30-60 Horsepower FourStroke Voltage Regulator Replacement Models Affected

30-60 Horsepower FourStroke Voltage Regulator Replacement

- a - Voltage regulator
- b - Fuse harness connector to voltage regulator
- c - Fuse harness connector to wiring harness
- d - Cable tie securing fuse and harness
- e - 25 ampere fuse assembly

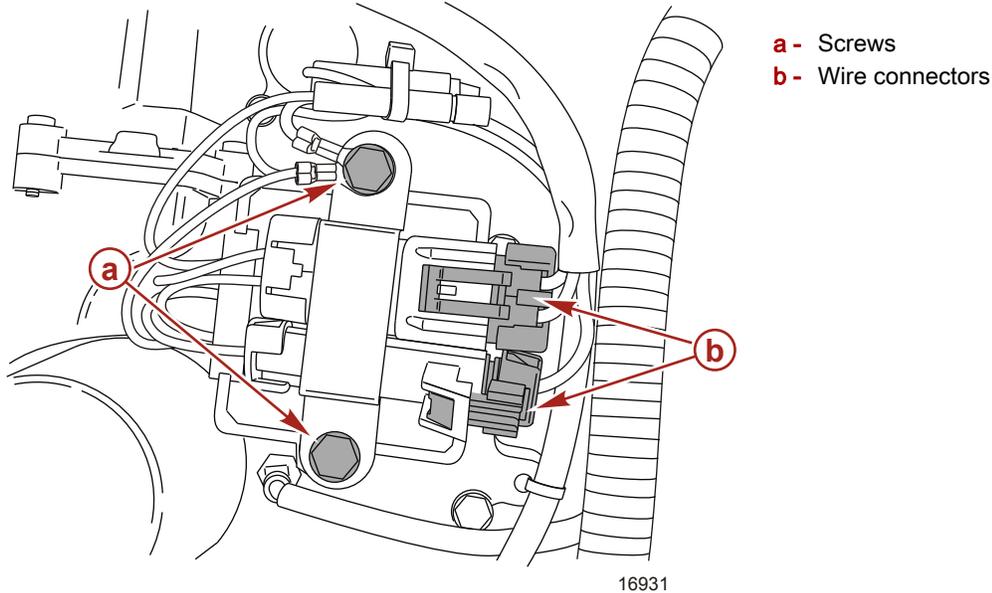
Inspect the engine for the installation of a fuse harness (c) required for the use of this new kit. If the fuse harness is installed, the bulletin has been performed on the engine and no further action is necessary.

- a - Exhaust cover gasket
- b - Exhaust cover
- c - Thermostat cover gasket
- d - Voltage regulator
- e - Pipe plug (drive tight)
- f - Screw (M6 x 35) (12 each)
- g - Screw (M6 x 40) (2 each)
- h - Thermostat
- i - Thermostat cover
- j - Elbow
- k - Temperature sensor
- l - Thermostat gasket

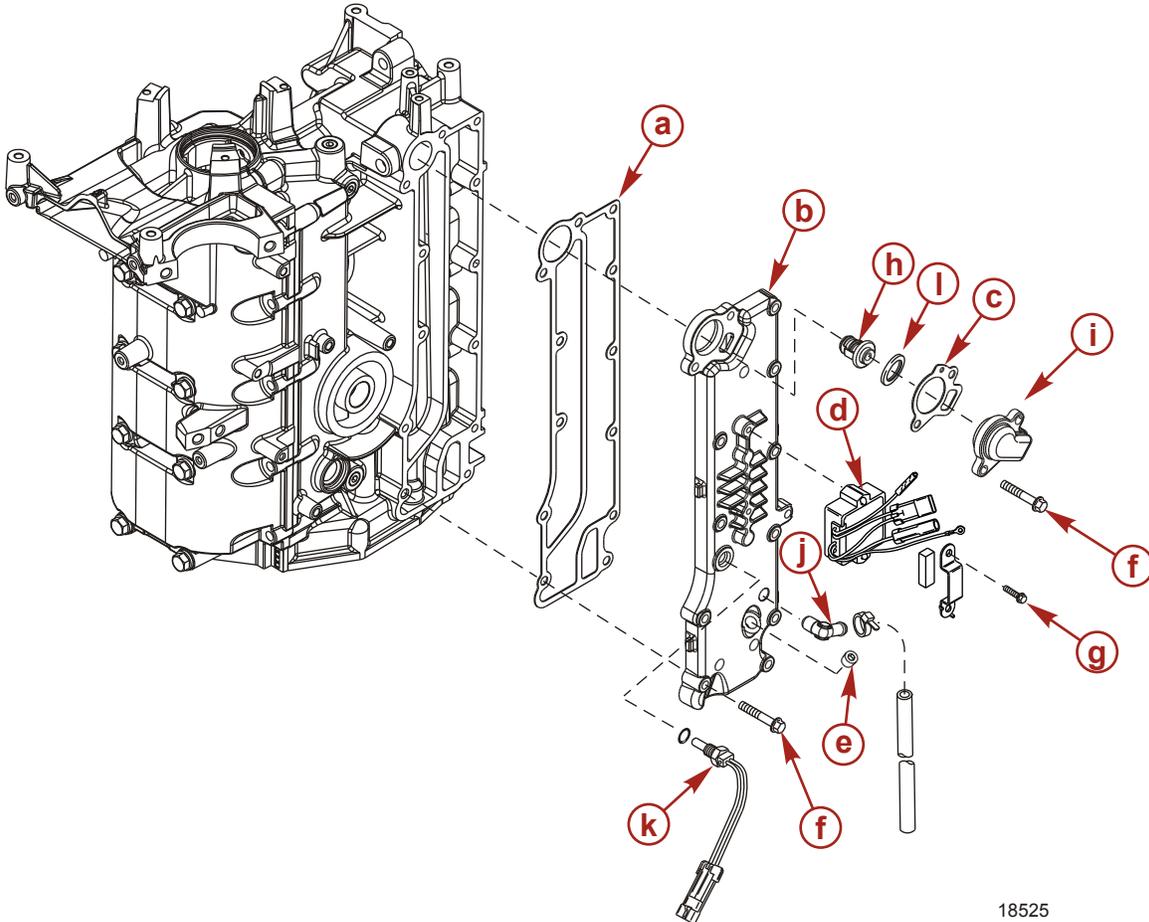
NOTE: The installation of this kit requires the replacement of the engine exhaust cover. Refer to the appropriate service manual for removal and installation instructions.

7. Remove the temperature sensor from the exhaust cover. (Retain for installation into the new exhaust cover.)
8. Remove the thermostat cover. (Retain for installation into the new exhaust cover.)
9. Remove the exhaust cover.
10. Properly clean the gasket surface of the exhaust chest.
11. Install the new exhaust cover with the gasket provided.
12. Install the new thermostat, thermostat cover, and new thermostat gasket to the new exhaust cover.

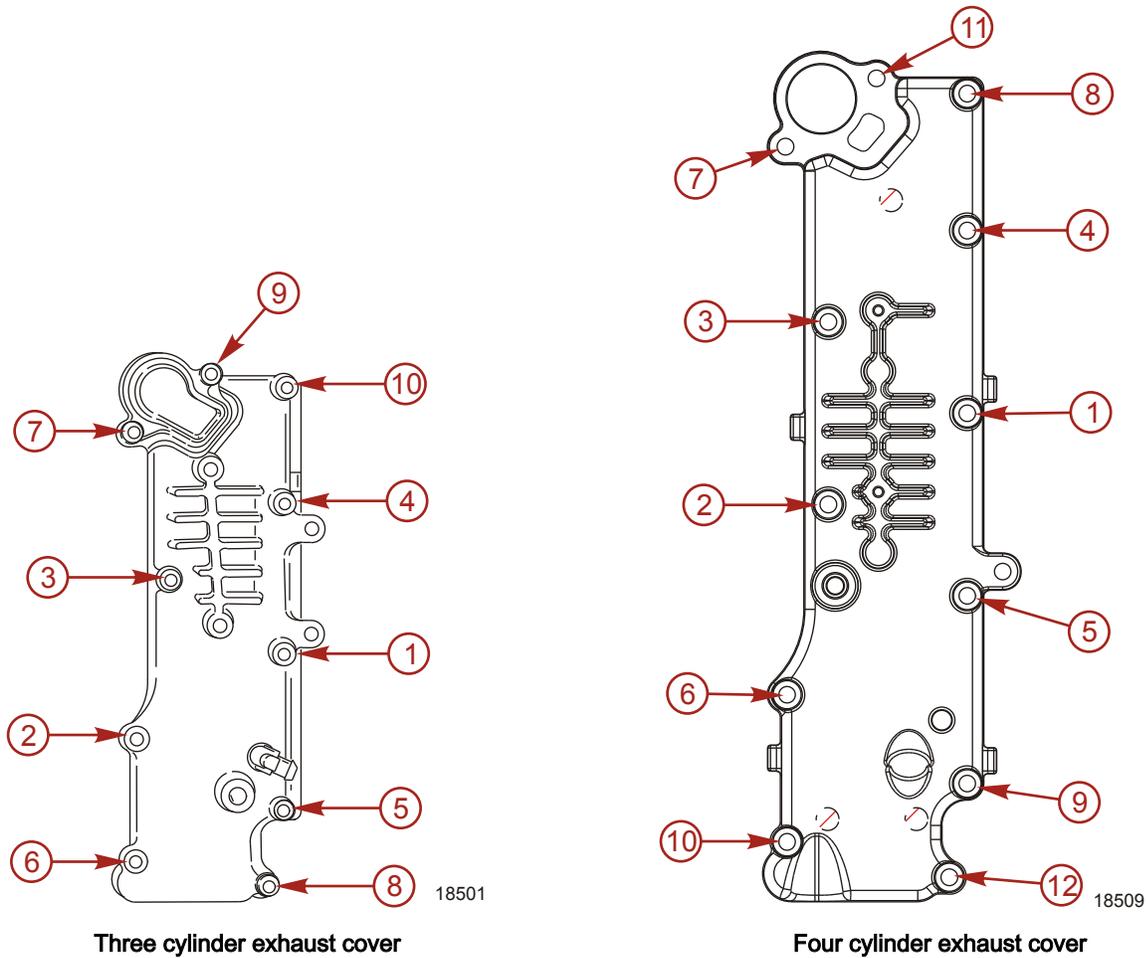
13. Torque the exhaust cover and thermostat cover screws in the proper torque sequence. Reference the correct sequence below.

Description		Nm	lb. in.	lb. ft.
Exhaust cover screw torque	First	6	53	
	Final	12	106

- a - Voltage regulator
- b - Fuse harness connector to voltage regulator
- c - Fuse harness connector to wiring harness
- d - Cable tie securing fuse and harness
- e - 25 ampere fuse assembly

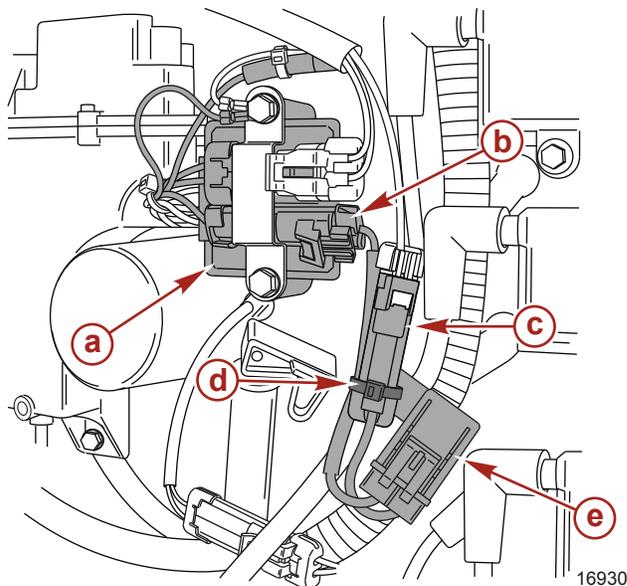
17. Route and secure wiring as shown.
